MEMORANDUM

SUBJECT: Modifications to the common mode boards

Refer to: LIGO-E1700364-v1

This document lists the modifications to the 4th generation TTFSS, based on PCB D1700346-v1 and on schematics <u>D1700077</u>, <u>D1700076</u> and <u>D1700078</u>.

Change 1:

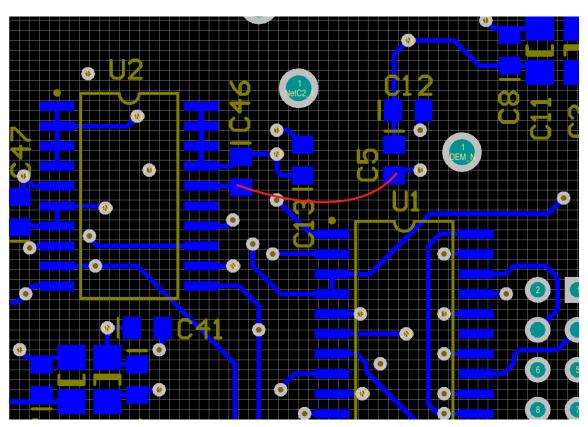
U2 is missing the +15V rail. Add a jumper wire between the C5 pad towards U1 and the C46 pad towards U1 (D1700077, bottom).

Change 2:

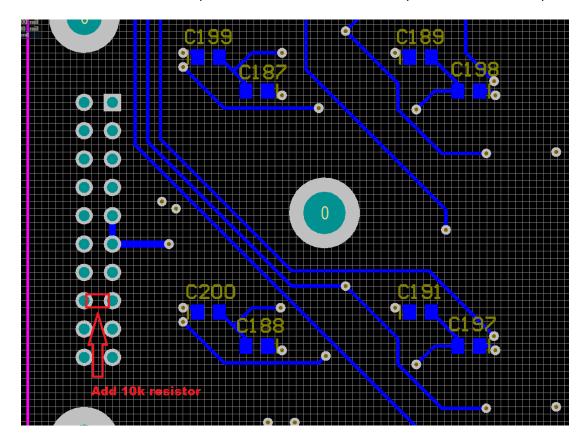
Input to U26 is floating when OPT4 is selected without an option board. Add a 10 k Ω resistor between pins 8 and 18 of header JP1 (D1700077, bottom).
